**Revised Interim Measures Work Plan
Sub-Areas 2B and 6B
The Boeing Company, Tract 1
Hazelwood, Missouri**

Re: Response to Comments Received from MDNR and St. Louis Lambert International Airport on the Interim Measures Work Plan Sub-areas 2B and 6B, Dated December 2011, The Boeing Company Tract I Site, Hazelwood, Missouri, MOD000818963

RESPONSE TO COMMENTS

RAM Group of Gannett Fleming, Inc.
5433 Westheimer Rd, Suite #725, Houston, TX 77057
Figure 3-1
Sub Area 2B Proposed Interim Actions
Boeing Tract 1
St. Louis, Missouri
PROJ. NO: 054517 D/B: RM DATE: 11/11

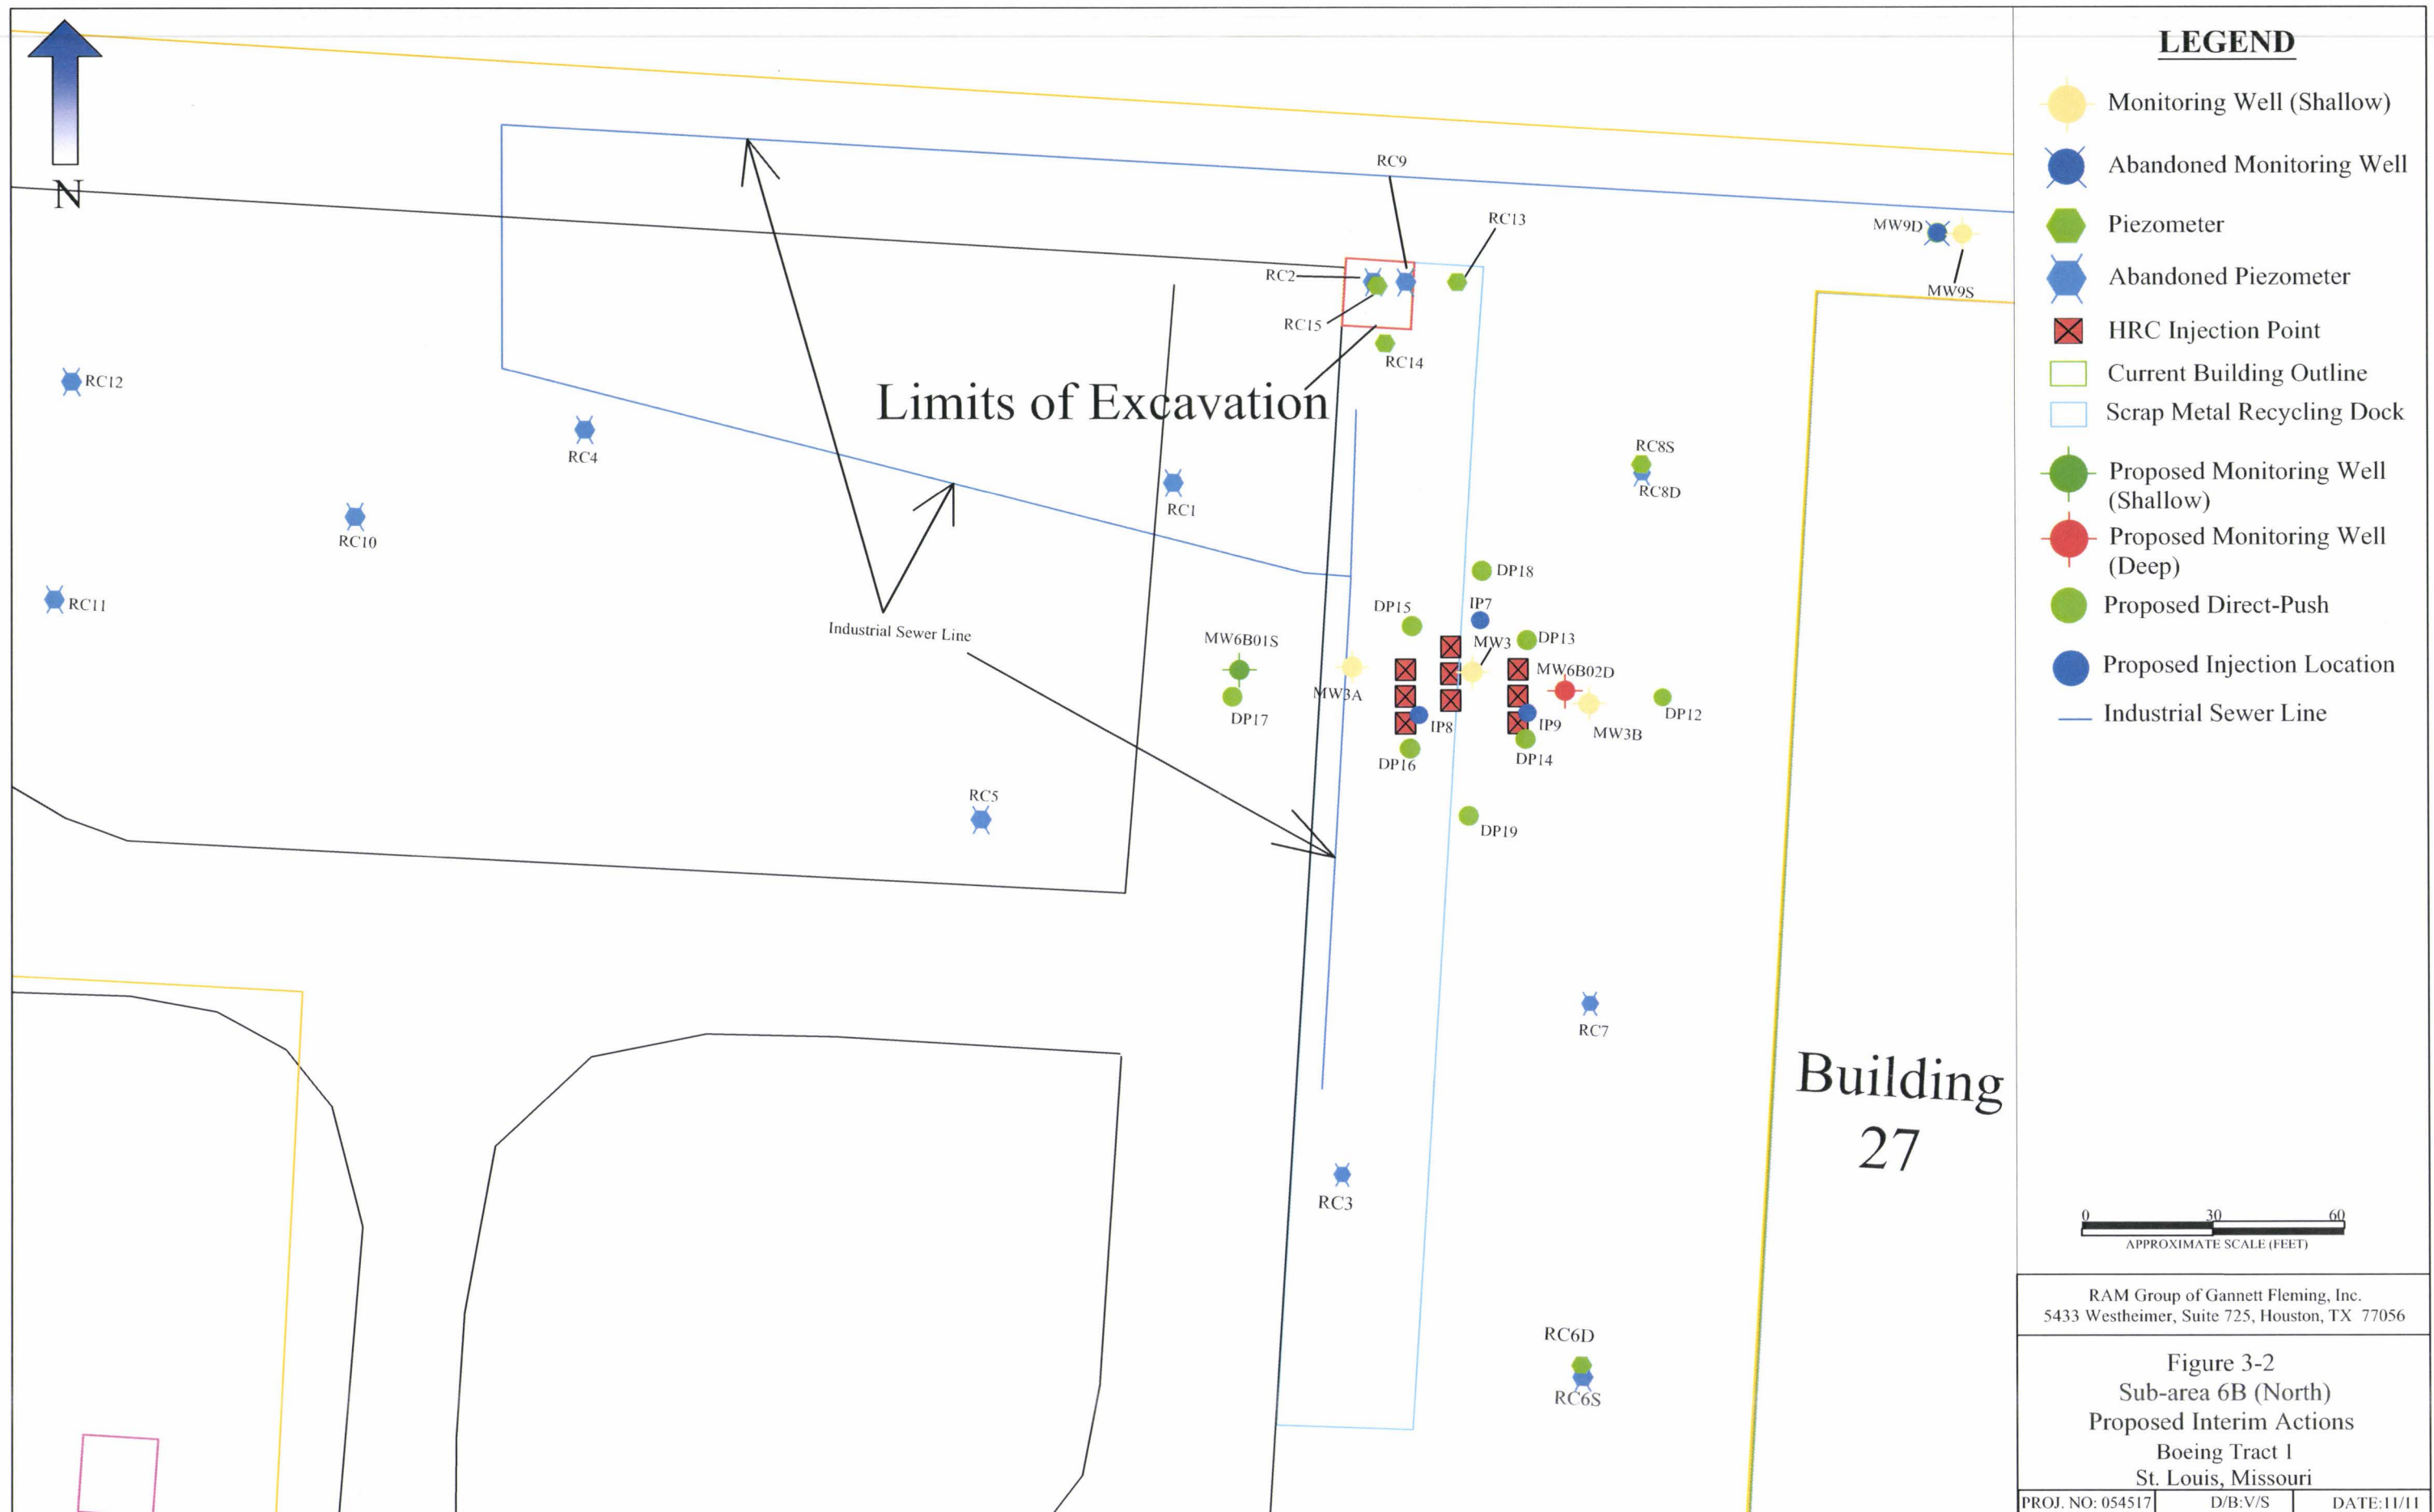
10. **Section 3.1.1, Sub-area 2B Phase 1, Page 3-1 and Section 3.1.2, Sub-Area 6B, Phase, Page 3-2:** The work plan should include a figure showing the proposed grid layout of geoprobe borings

Figure 3-1 of the Work Plan shows a red outline that appears to correspond to the former soil excavation area. A solid red area is also shown, which is not identified on Figure 3-1. It is unclear what the solid red area means.

Response: Figures 3-1 and 3-2 show the proposed locations of direct-push borings, additional monitoring wells, and ISCO injection points for Sub-areas 2B and 6B, respectively. A statement regarding the number and locations of borings may be adjusted based on field screening has been added to Section 3.1.1.

Response: Additional details regarding design of the direct-push injection program have been incorporated in Section 3.1 of the Work Plan. These details include current assumptions for: oxidant to be injected; locations for limited direct-push investigation, monitoring wells, and injection points; and volume to be injected. Additional information is provided on Figures 3-1 and 3-2 and in Table 3-2 regarding monitoring locations, construction details, and rationale for selected locations. Additionally, Figure 3-1 has descriptors that show the red outline denotes the Extent of Excavation and the solid red area denotes SWMU 17.

Figure 2-5
Regional Bedrock
Geology Map
Boeing Tract 1 RFI
Hazelwood, Missouri

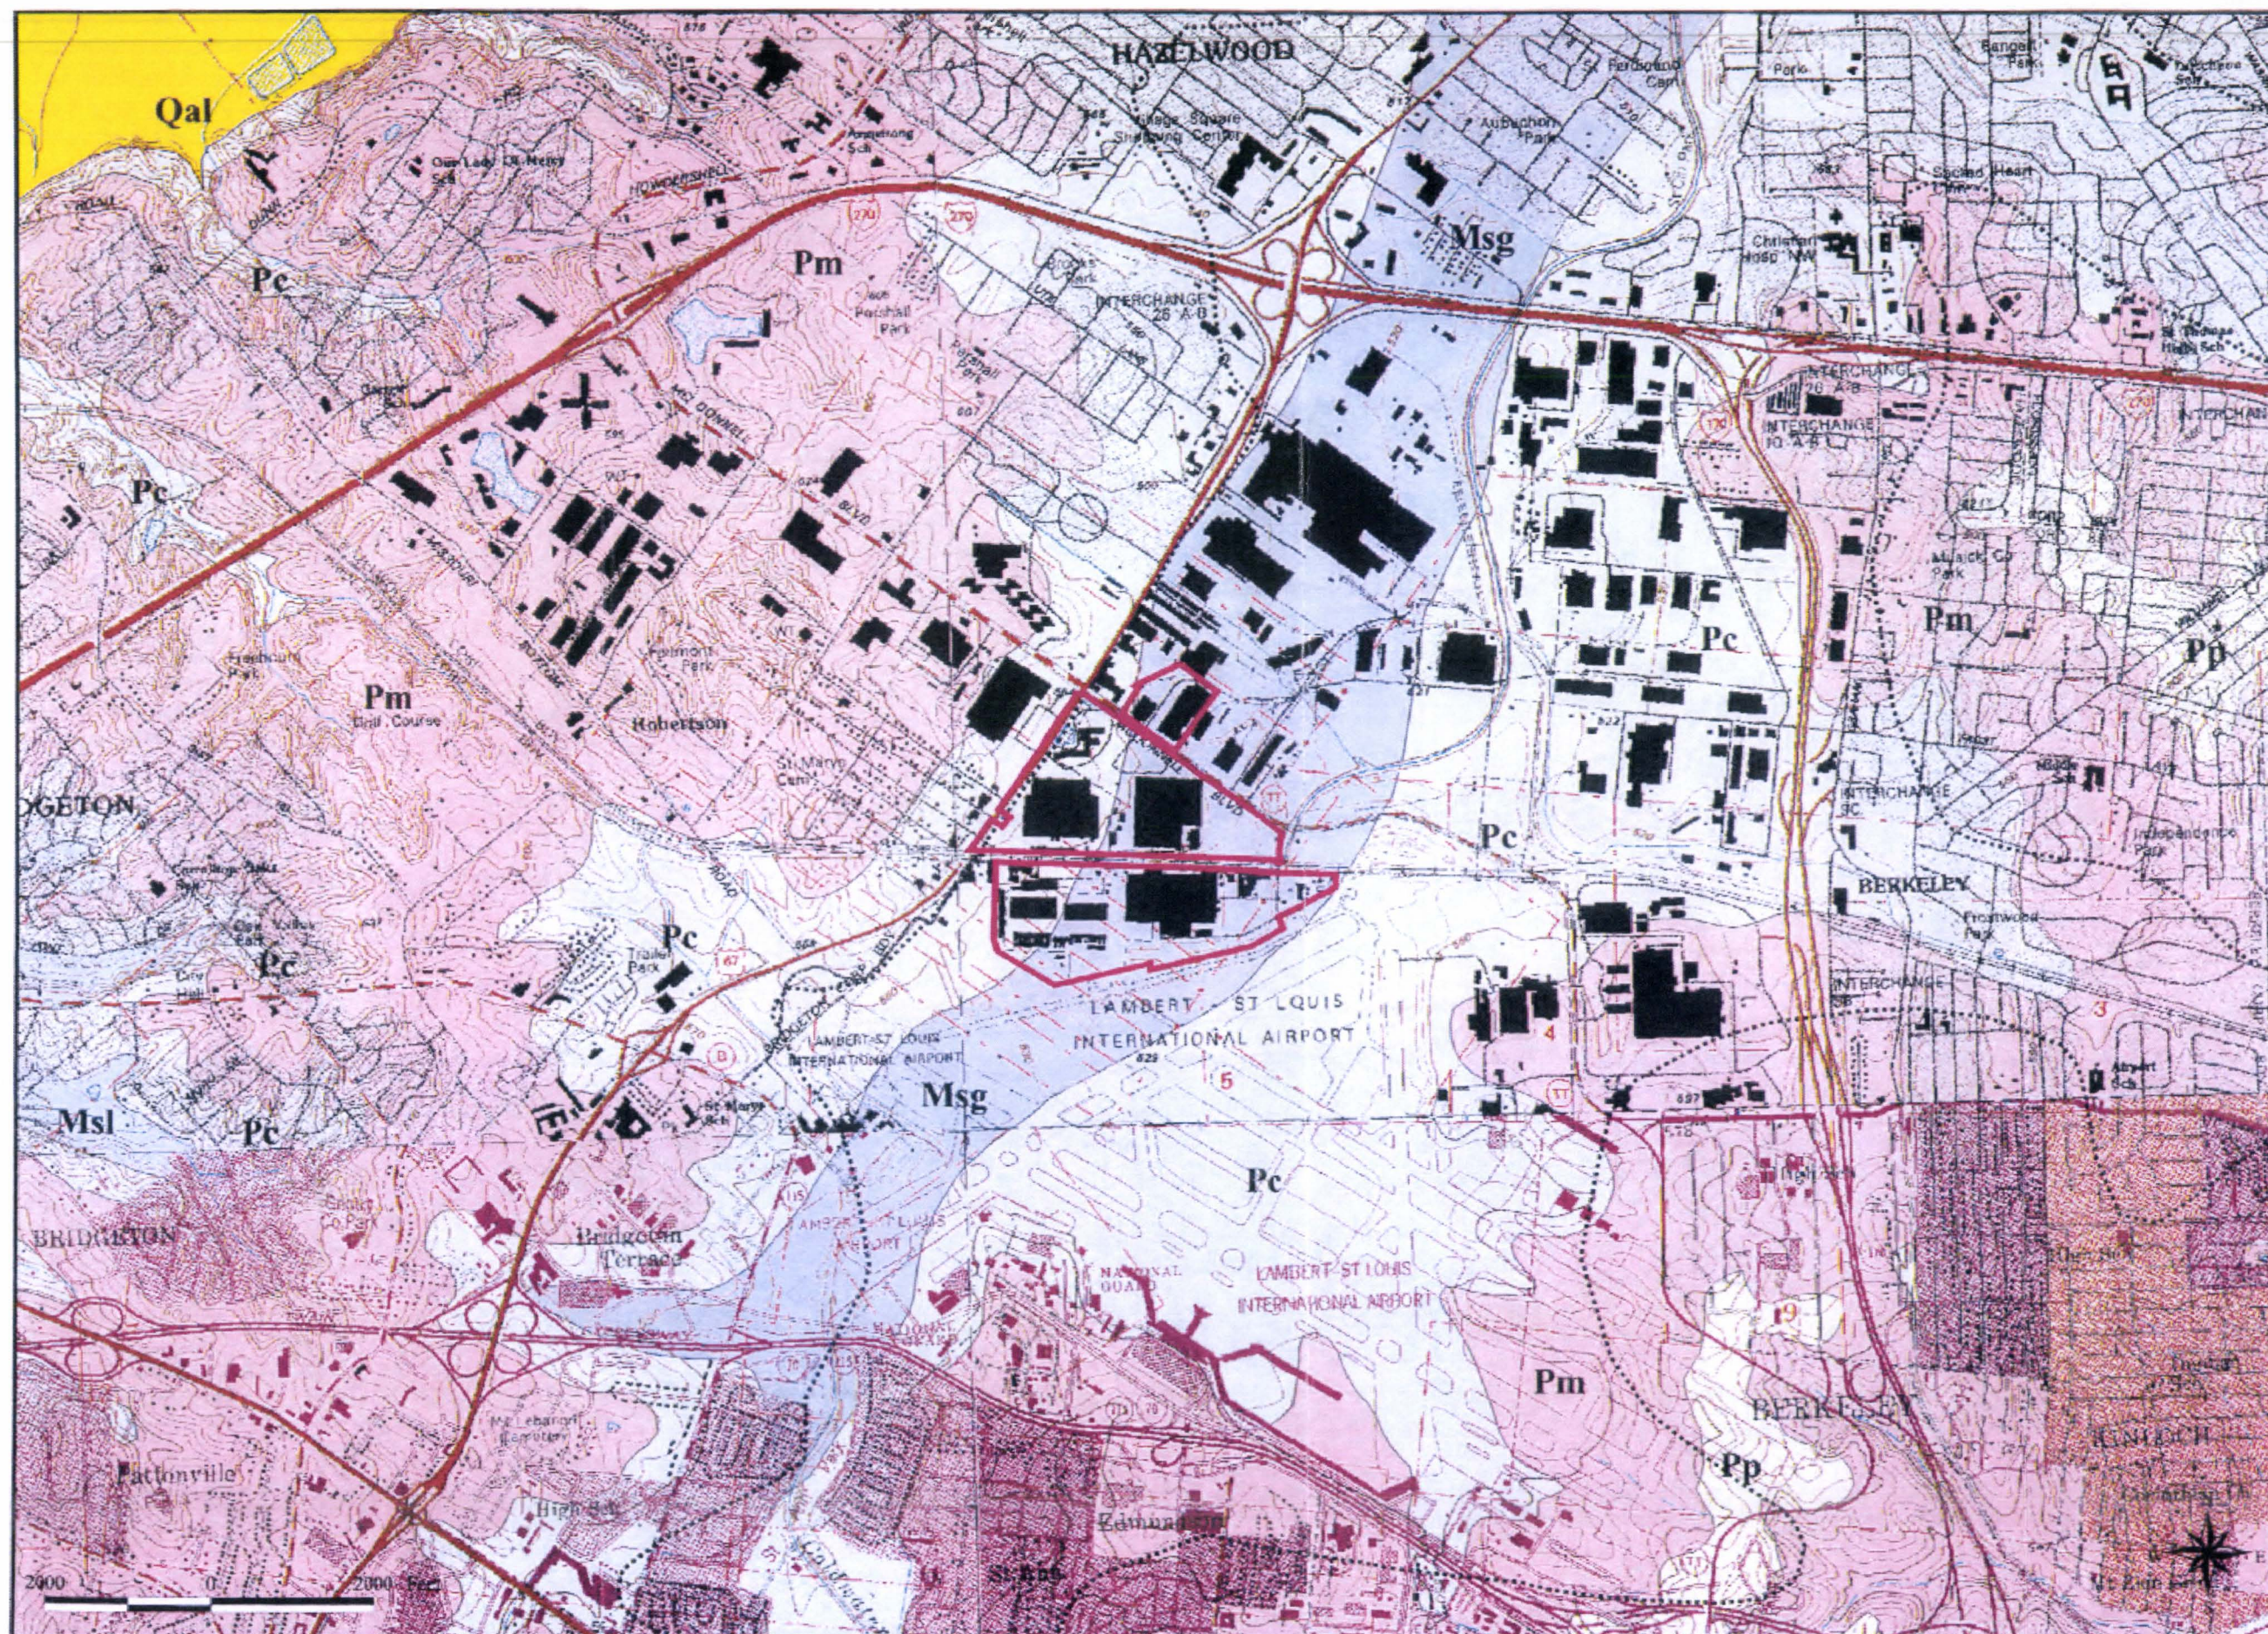
- c. Geological features present within a quarter mile radius of site;

Response: Figure 2-5 from the RFI (MACTEC, 2004) presents the bedrock geology of the site and vicinity. A copy of Figure 2-5 has been included in Appendix A. A detailed discussion of the bedrock geology is provided in the RFI.
